California Department of Transportation

December 18, 2025

11-IMP-86
PM 4.5
McCabe Ranch II Tract Map 994
Supplemental EIR (SCH#2024050879)

Source: Preliminary Project Plans (Caltrans Project ID 1100000384 – EA 11-29420).

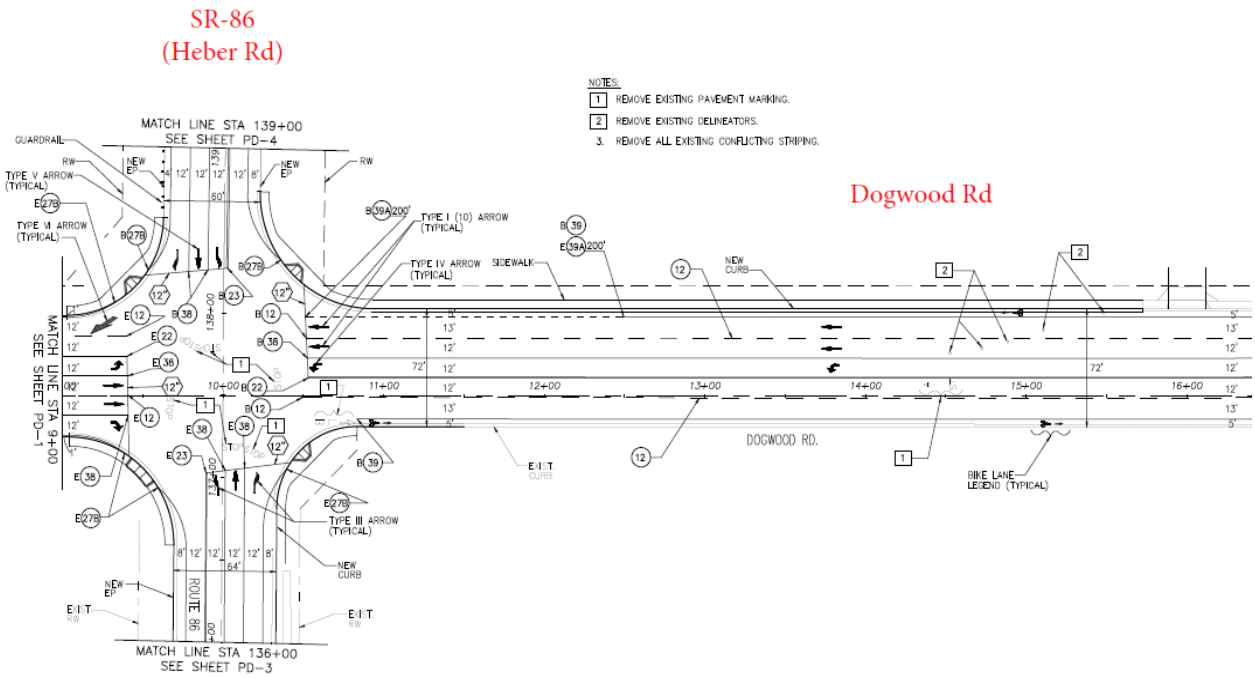
Page 4.10.47 of the Draft Supplemental Environmental Impact Report of the McCabe Ranch II Tract Map 994 project (Section 4.10.6.2. "New Proposed Mitigation Measures" -MM TR.1: Project Phase 1 Improvements) recommends signalization of the Heber Road / Dogwood Road intersection. It also proposes similar lane configuration improvements as those proposed by Caltrans Project ID 1100000384 (EA 11-29420) with the exception that McCabe Ranch II Tract Map 994 Project recommends one southbound right-turn lane, while Caltrans project does not.

Some tables of the Draft Supplemental Impact Report of the McCabe Ranch II Tract Map 994 refer to the Heber Road / Dogwood Road intersection as "Intersection 35" whereas Table 4.10-15 and Section 4.10.6.2 refer to it as "Intersection 36."
All designs within Caltrans' R/W shall comply with the latest Highway Design Manual (HDM) per DP-36, and Director's Policy 37 (DP-37) on complete streets.

- Please provide the necessary R/W on SR-86 for a left turn pocket (6'), three lanes (12' each), a shoulder (8'), a bike lane (8'), a sidewalk (6'), and curb & gutter (1.5'). That will sum up to 65.5' from center line of roadway.
- Please calculate queue length for through and left turn lane per signal time.
- Please consider pedestrian volume and design pedestrian crossings accordingly.
- Please design all components on SR-86 per the latest HDM as mentioned below:
    - HDM Topic 205 – Road Connections and Driveways (Access openings should not be spaced closer than one-half mile to an adjacent public road intersection or to another private access opening that is wider than 30 feet).
    - HDM Topic 309 – Clearances
    - HDM Topic 404, 404.5 Truck Turning Templates
    - HDM Topic 4.5 Intersection design

RIGHT OF WAY MAP

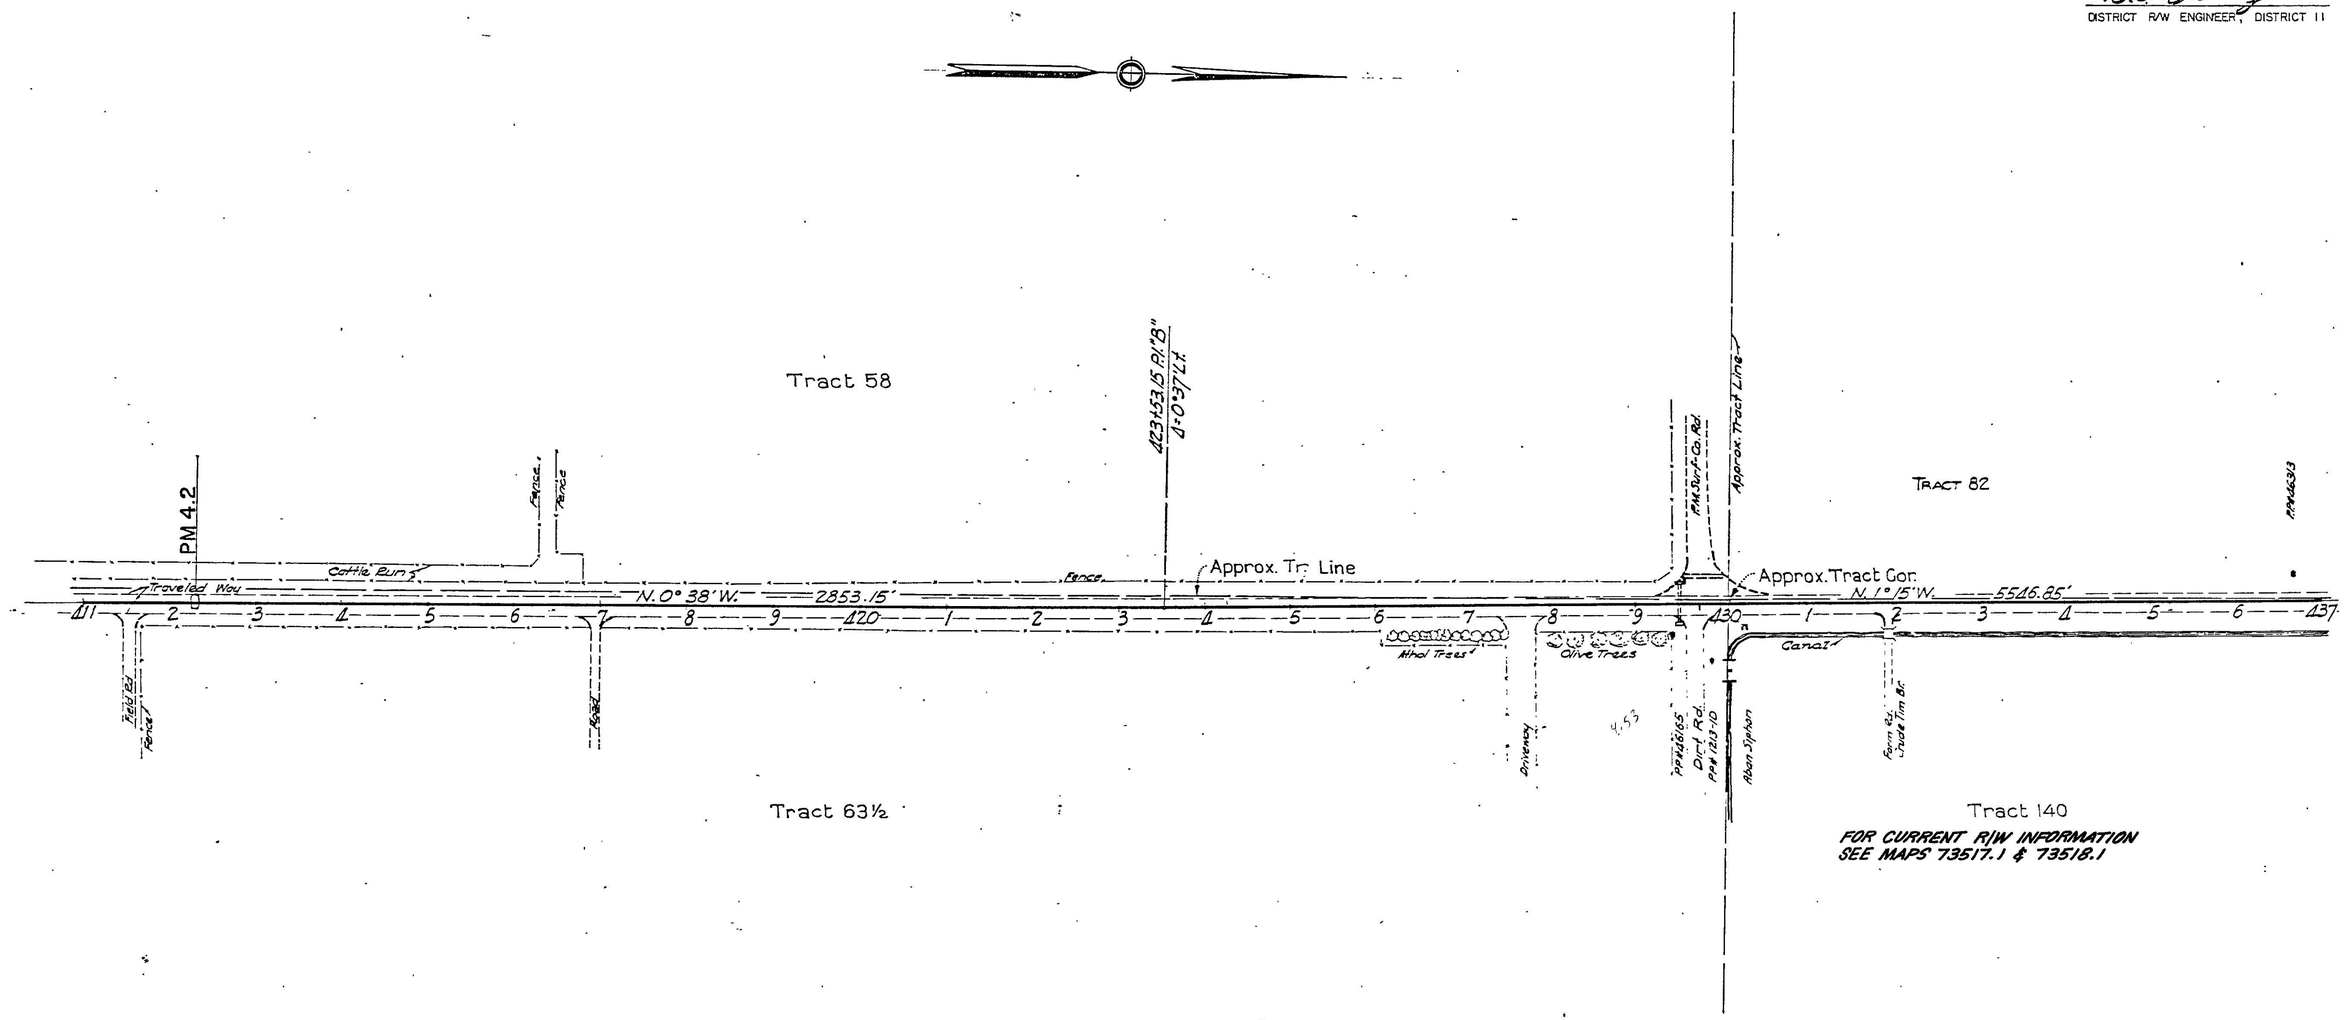
Right-of-Way
The applicant will need to submit any documentation related to the existing Right of Way on SR-86 along the project frontage (if any). Caltrans would like to know how the applicant has determined the Easterly R/W of SR-86? Is there an existing easement document? If so, please provide it to Caltrans for review. If not, Caltrans would require a dedication on the map to perfect Caltrans' rights.

As a condition of approval, it would be asked that the developer donate the required R/W according to Caltrans' standards and prepare a Right of Way Map depicting the dedication (see attachments, I0860401 Right-of-Way Map, I0860402 Right-of-Way Map, and Dedication Process per Right-of-Way Manual Chapter 6.20.00).
